MIL-P-17639F (SH)
AMENDMENT 4
22 FEBRUARY 1996
SUPERSEDING
AMENDMENT 3
25 May 1995

PUMPS, CENTRIFUGAL, MISCELLANEOUS SERVICE,
NAVAL SHIPBOARD USE

This amendment forms a part of MIL-P-17639F(SH), dated 18 February 1986, and is approved for use within the Naval Sea Systems Command, Department of the Navy and is available for use by all Departments and Agencies of the Department of Defense.

FIGURE 1A - IMPELLER BETWEEN BEARINGS

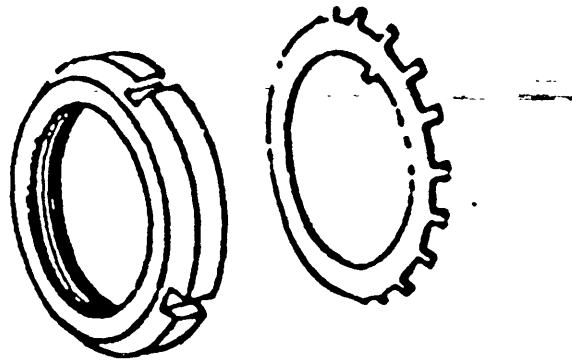
"3.3.5.2 Impellers shall be keyed or, the shaft and securely held against movement by locked nuts or other means approved by the design review agency (see 6.2.1). Impellers between bearings shall be restrained in a manner similar to that shown in Figure 1A. Impellers not between bearings shall be restrained in a manner similar to that shown in Figure 1B."
